Mozilla Existing 310 sq ft Cage is CG.025 and 50sq purchased expansion of CG.026.A 180sq ft. Cage 25 power in racks 6, 8, 10, 12 will change from 30/120 to 30/208.

LABEL			
		Mozilla			
DRAWN	James Nolan	SIZE	FSCM NO	DWG NO	REV
ISSUED	1/26/12	8.5x11	n/a		1.A
		SCALE	1:60	SHEET	1 OF 1

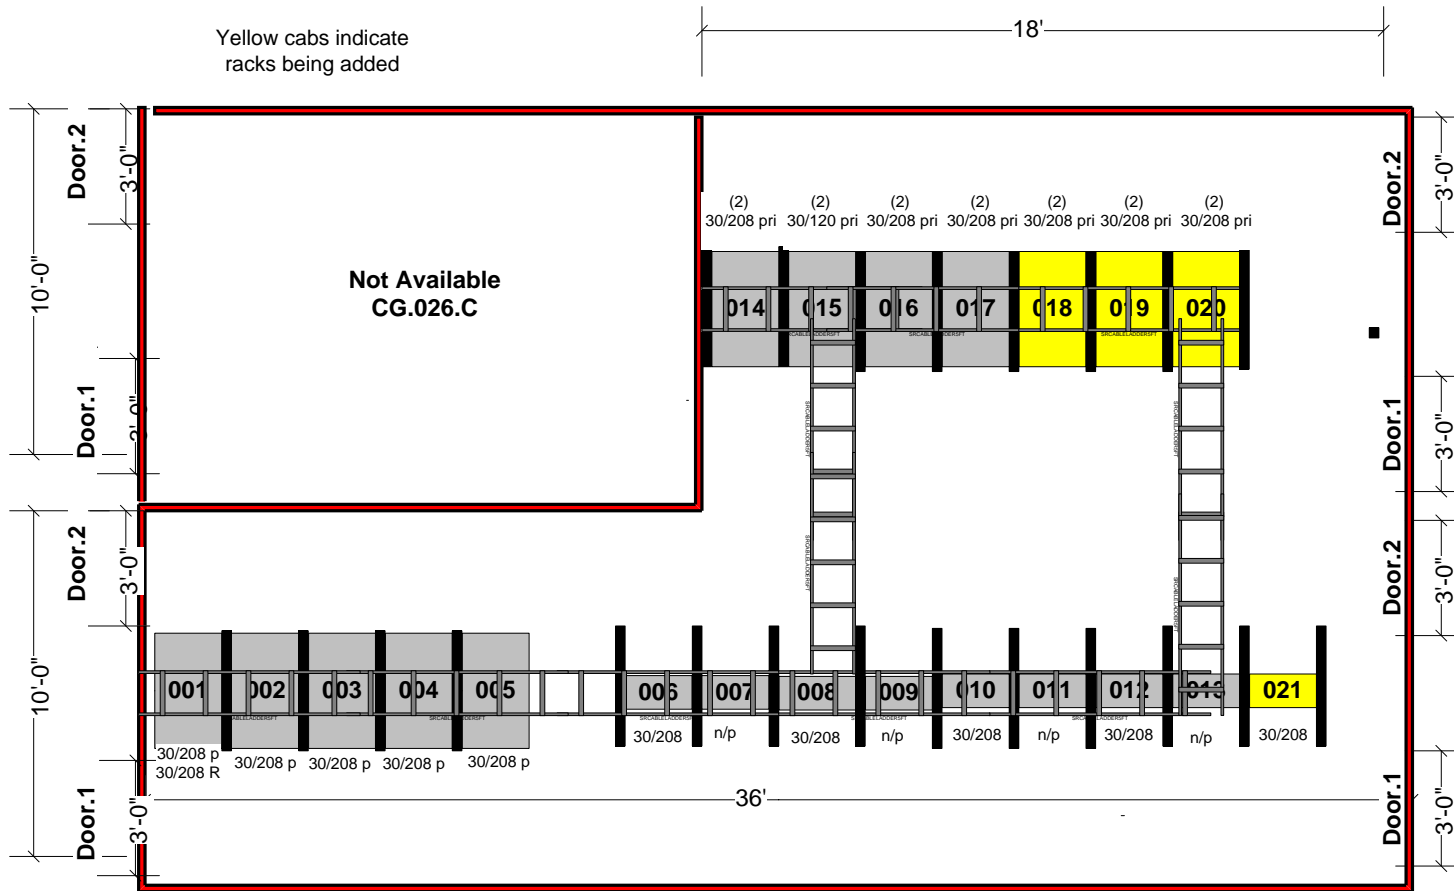
- 1) Racks 006, 008, 010, 012 have 30/120 circuits that will be swapped out to 30/208
- 2) Racks 18,19,20 will get (2) primary 30/208 whips with dual plugs
- 3) Rack 21 will get a new primary 30/208
- 4) expand cage 25 an additional 50 feet
